Nomination Form
Anadromous Waters Catalog

Anadromous Waters Catalog Number of Waterway 101-47-10145-2005

ROUTE CORRECTION

Figure 2.— 101-47-10145-2005 Route Correction map.

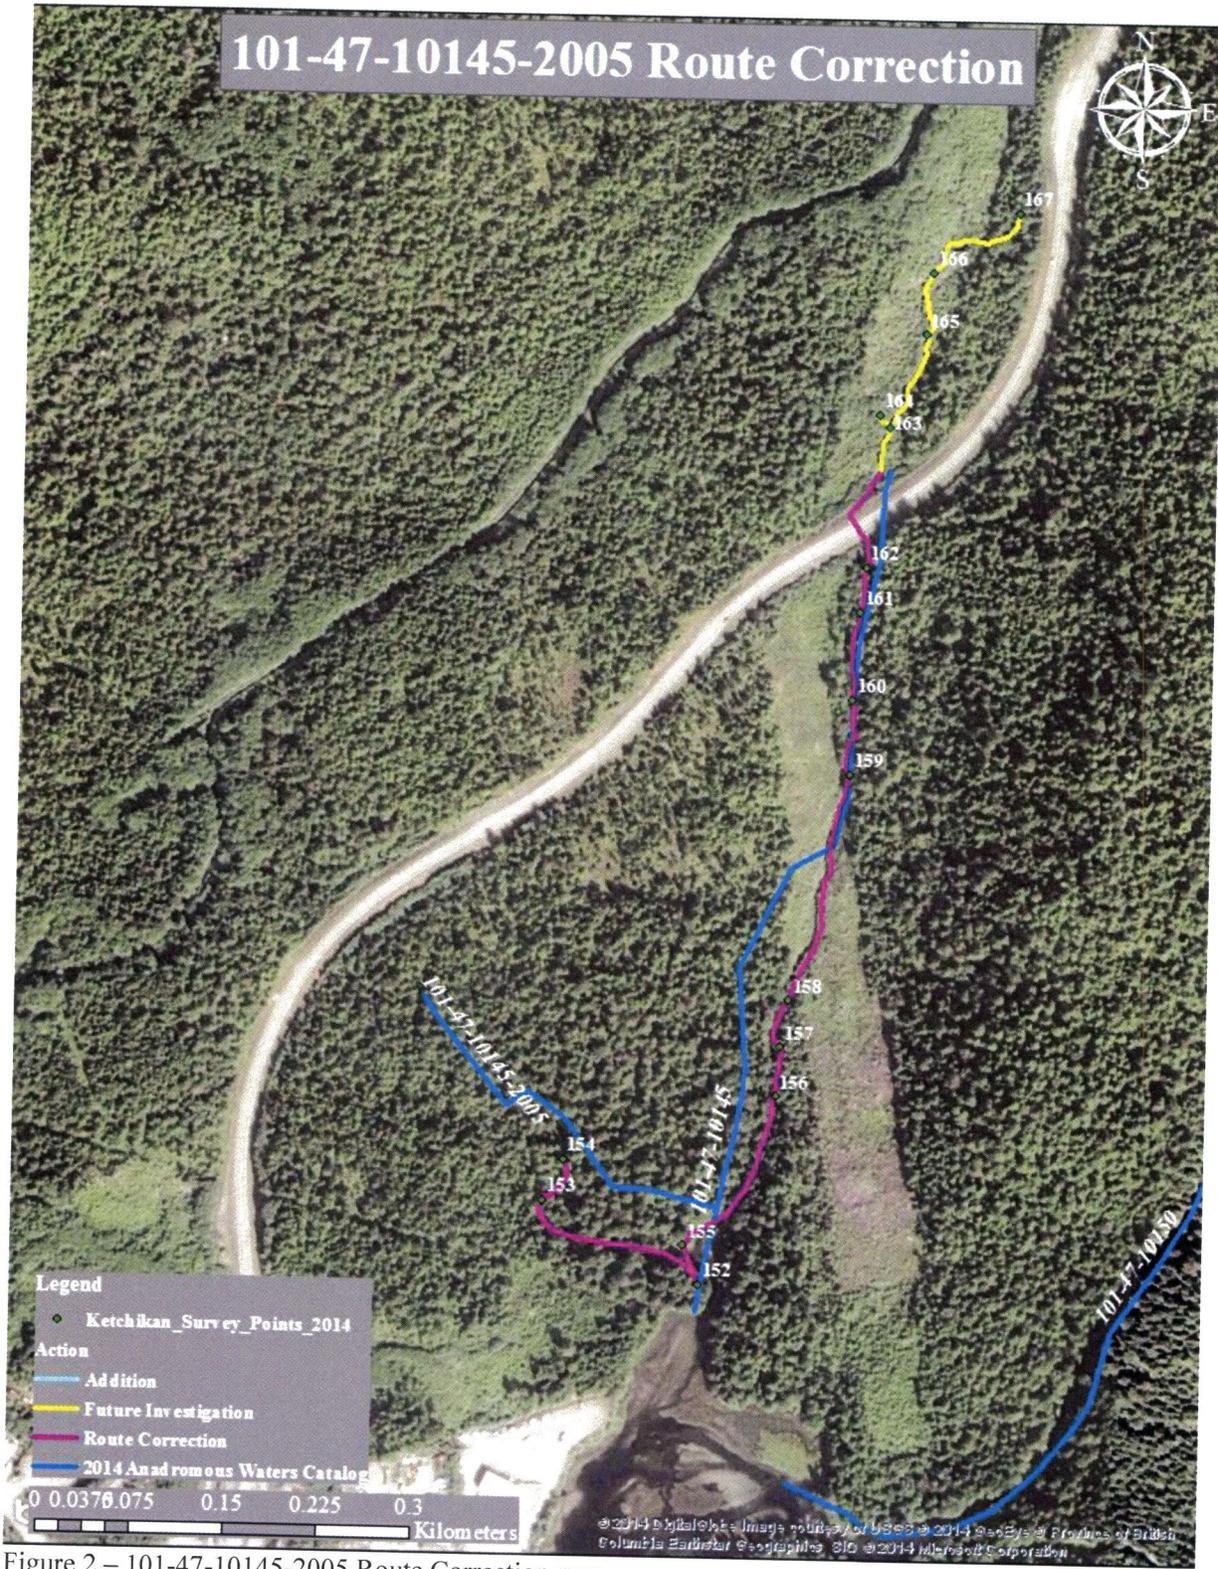
Findings: This stream's actual route differs from that in the AWC..

update 101-47-10145-2005 hydro (light blue line) w/
purple line & shorten stream, use norms\quinn\ketchikan\Action\Action.shp for hydro

Recommendations: Please update this stream's mapped course to reflect the field-verified route in the AWC, and maintain species currently cataloged.
